Product Change Notification—PCN# PCN001214

August 10, 2026

We would like to inform you that Moxa is going to make changes to multiple products series. These changes will be implemented as a running change from August 17, 2026. Please review the details below to determine how these changes will affect your products and/or operations. The affected series are as follows:

Example Case 1:

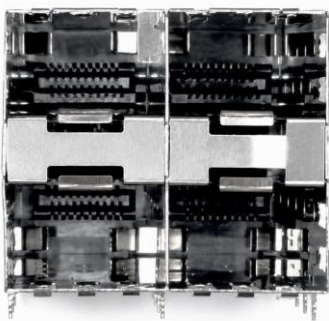
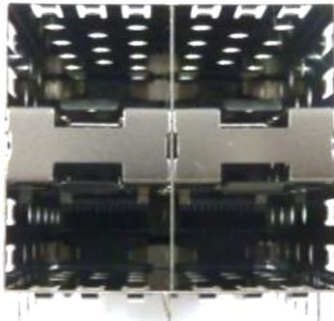
To maintain a stable supply, the SFP cages used in the listed products will be changed. The material of the SFP cage will change from copper alloy to copper-nickel alloy. Minor appearance changes will also be introduced. These changes will not affect the dimensions, form, fit, function, or reliability of the products.

Representative images of the previous and new SFP cages are included as follows:
